RE: P.Z. 13-2023 17551, 17555 & 17599 Chesterfield Airport Rd. (Baldrige-Ryken, LLC): A request for an ordinance amendment to create a new “PC” Planned Commercial District for three parcels zoned “PC” Planned Commercial and “NU” Non-Urban and totaling 2.9 acres located on the north side of Chesterfield Airport Road, east of Long Road (17U140252, 17U140263, and 17U140203).

Planning Commission Staff Report

Meeting Date: November 13, 2023

Figure 4: Preliminary Development Plan

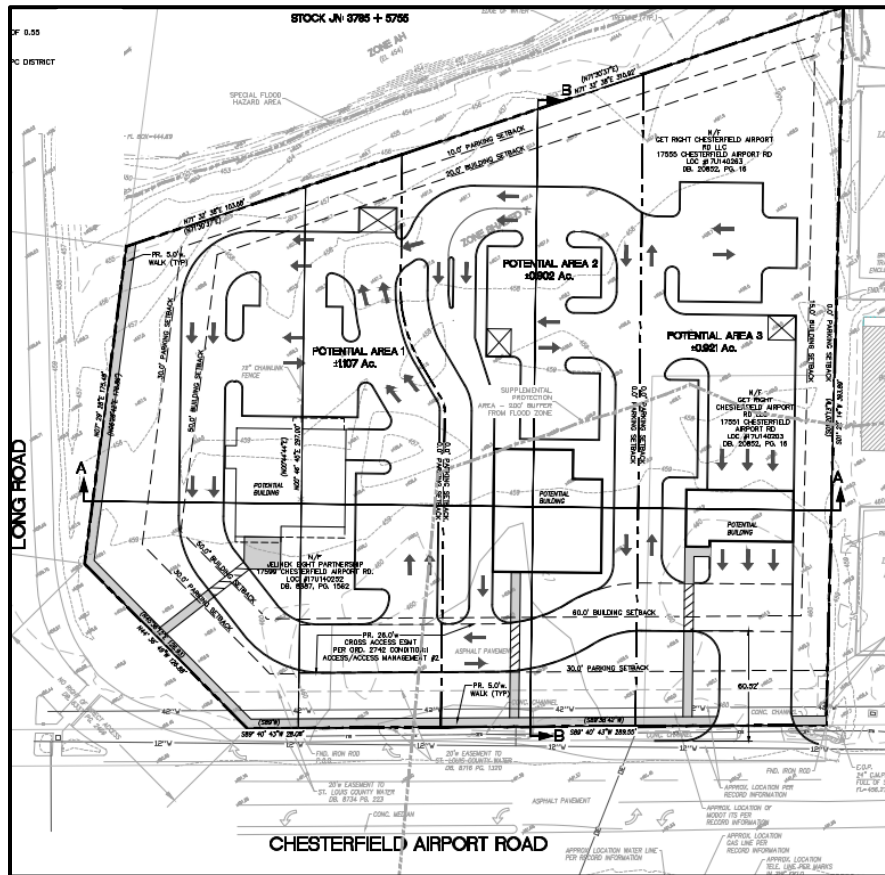
Concerns were raised regarding the proposed zero (0) feet parking setbacks for potential lots one (1) and two (2). Provide an explanation for requesting the proposed parking setbacks.

Concern was raised regarding the traffic to be generated by the potential intensity of having multiple drive-thru facilities. Provide information on how the development team will be addressing this concern.

Response: This development is intended to be three (3) different businesses sharing drives and parking access. The zero (0) feet internal lot line setback is common with many City Developments.

Response: Applicant updated the "Preliminary Development Plan" to address vehicular circulation.
